Process Sheet

Customer	: CU-DAR001 Dart Helicopters Services			Drawing Name	: SUPPORT BRACKET		
Job Number	: 25073			Part Number	: D23623		
Estimate Number	: 10260			Drawing Number	: D2362 REV E1		
P.O. Number	: N/A			Project Number	: N/A		
This Issue	: 12/2/2005 S.O. No. : N/A			Drawing Revision	: E1		
Prsht Rev.	: NC			Material	: N/A		
First Issue	: 12/1/2005 Type : MACHINED PARTS			Due Date	: 12/8/2005 Qty: 2 Um: Each		
Previous Run	: N/A						
Written By	: See comment below						
Checked & Approved By	: See comment below						
Comment	: Est: G 00.05.18 Added inspection level 8 EC

DESIGN BV	DRAWN BY GP	DART AEROSPACE LTD
CHECKED KE	APPROVED H	HAWKESBURY, ONTARIO, CANADA
DATE 98.12.04	TITLE STEP SUPPORT BRACKET	REV. E
A	95.02.15	NEW ISSUE
B	95.03.22	CHANGED RUBBER TO D2397
C	96.01.22	ADD D2362-5
D	97.05.21	ADD D2362-7
E	98.12.04	REDRAWN, ADD 2397-5

From: David Shepherd [davids@dart Aero.com]
Sent: Thursday, December 01, 2005 8:11 PM
To: Linda Lacelle
Subject: Re: D2362

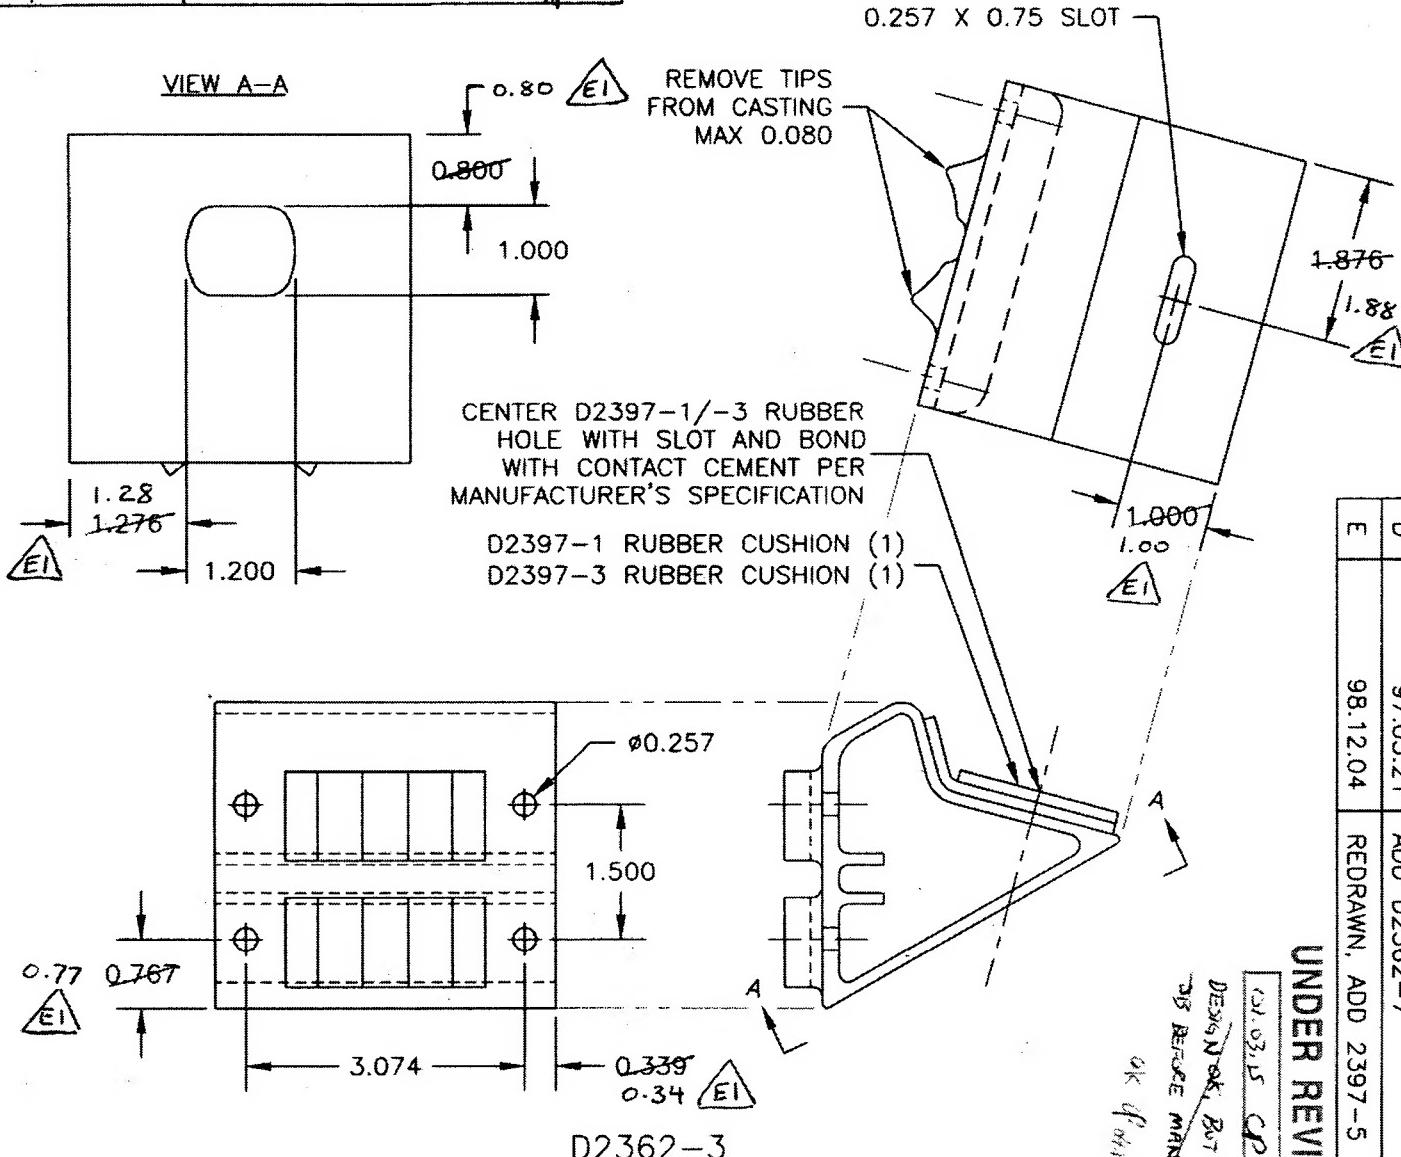
Looking at drawing D2362 Rev. E1, I think you can take a D2362-5 and convert it into a D2362-3.

You would have to add the 0.257 x 0.75 slot shown on page 1 and convert the existing 0.257 x 0.75 slot shown on page 2 into the 1.00 x 1.20 cutout shown on page 1. Then you would have to machine to remove the R16.68 shown on page 2.

>
> David,
> Is there much of a difference from D2362-5 AND D2362-3 ? Can we take a
> D2362-5 and make it into a D2362-3 ?
> LL
>
>

Add the rubber and voila, D2362-3.

DESIGN BN	DRAWN BY <i>JP</i>	DART AEROSPACE LTD HAWKESBURY, ONTARIO, CANADA
CHECKED <i>RE</i>	APPROVED <i>JP</i>	DRAWING NO. D2362
DATE 98.12.04	TITLE STEP SUPPORT BRACKET	REV. E SHEET 2 OF 3 SCALE 1:2

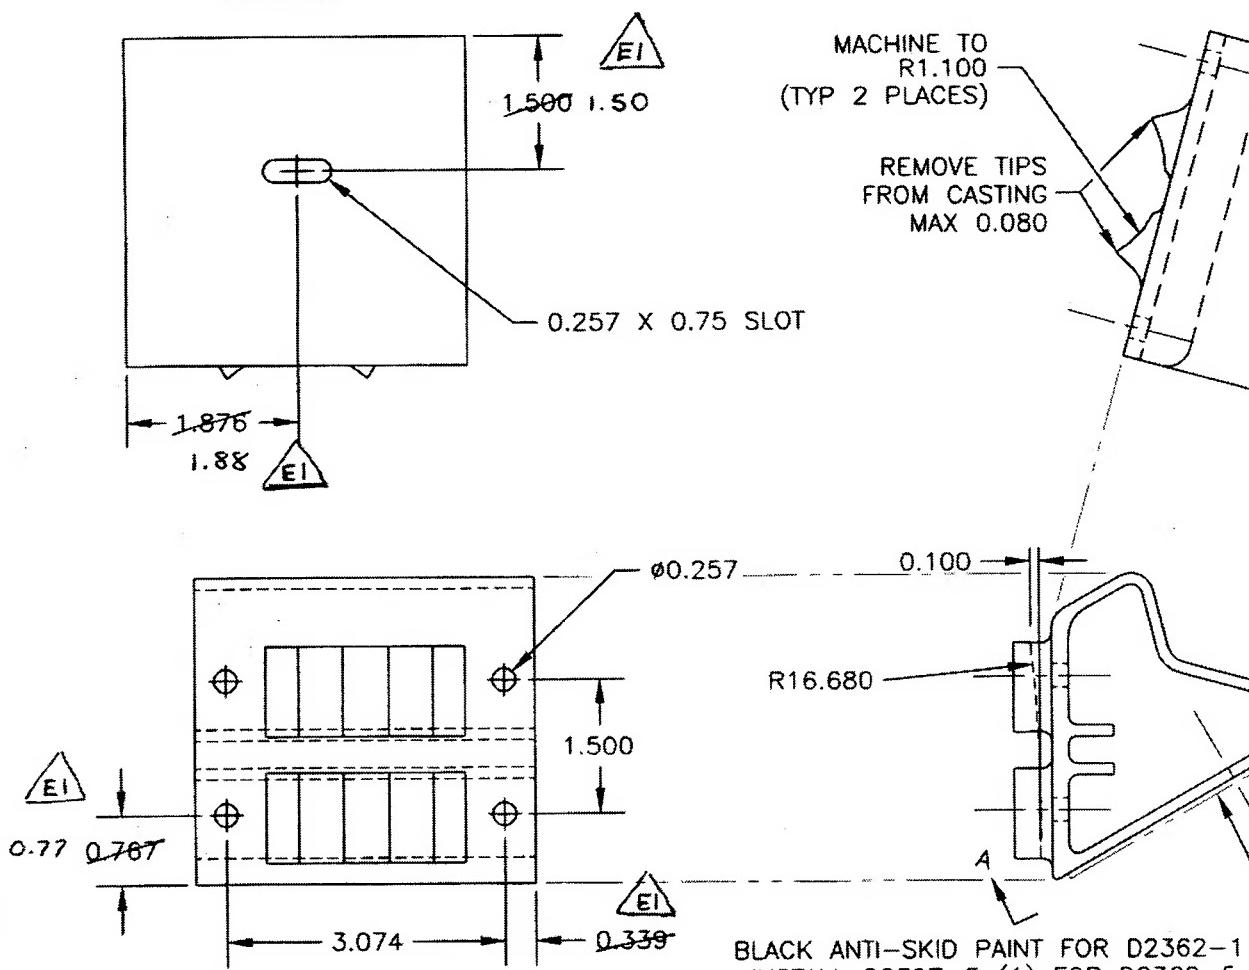
RELEASED
12/14/98
UNDER REVIEW
D2362-5 CP
DESIGNER, BUT CHECKED
BY BENTON MANUFACTURE
OK for D2362-5

DESIGN BY	DRAWN BY	DART AEROSPACE LTD
BW		HAWKESBURY, ONTARIO, CANADA
CHECKED	APPROVED	DRAWING NO.
RE	M	D2362
DATE		SHEET 3 OF 3
98.12.04		SCALE
		1:2

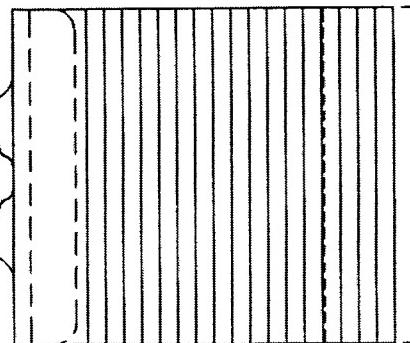
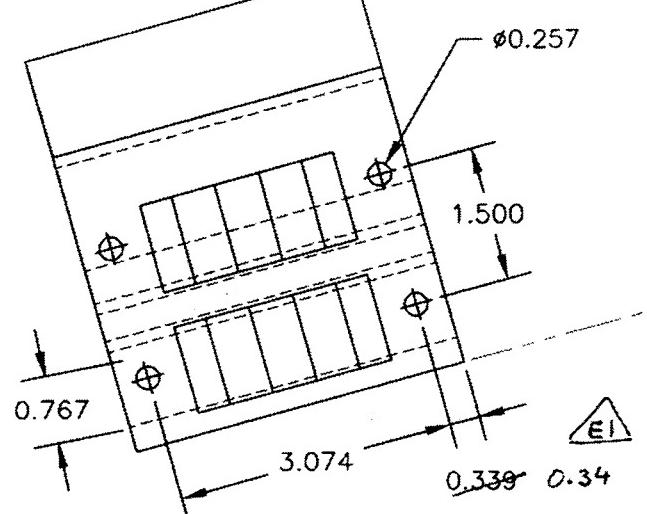
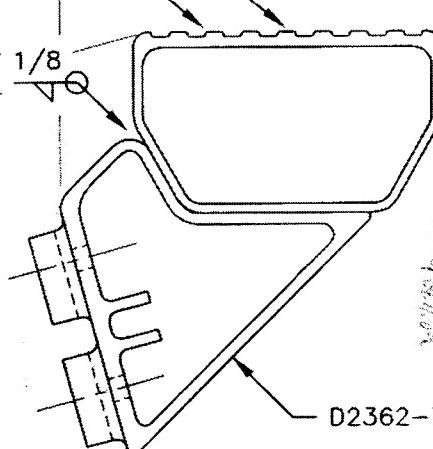
516315 CP
DESIGN OK, BUT CHECK NO. 111
3/3 BEFORE MANUFACTURE

OK FOR USE
